M-153

MARK IV REDESIGN COMMITTEE

MINUTES OF MEETING NO. 6

November 12, 1959

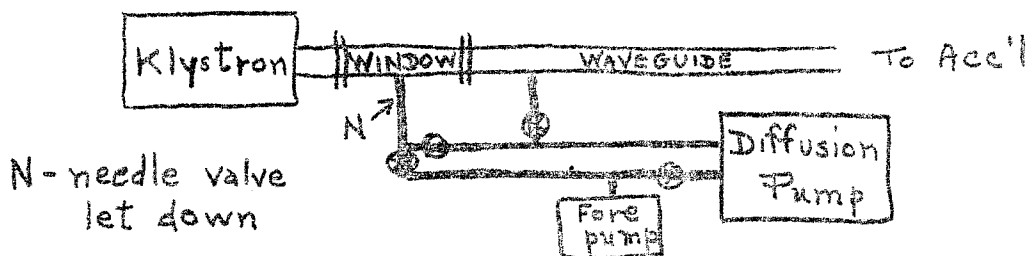
- e. The accelerator water jacket. Information has been obtained by Mr. Goerz from the Elco Manufacturing Company in Berkeley that they can supply us with a stainless steel tubular jacket that would be bored twice and honed. The SS tubes will have a tolerance of ± 0.003 inches on the diameter, and ± 0.005 inches in the straightness of the tube over the entire 10-foot length. For an experimental section of

two 10-foot sections, it will cost us \$68.50 per foot. If this method is to be used on the production of Project M, he has a price quotation of \$54.00 per foot for the production item.

Comment: It should be conceivable to use the bored and honed tubes at \$68.50 per foot for the two 10-foot sections on Mark IV, switching to the mill run from the manufacturing point for the Project M, with very little change in tolerances.
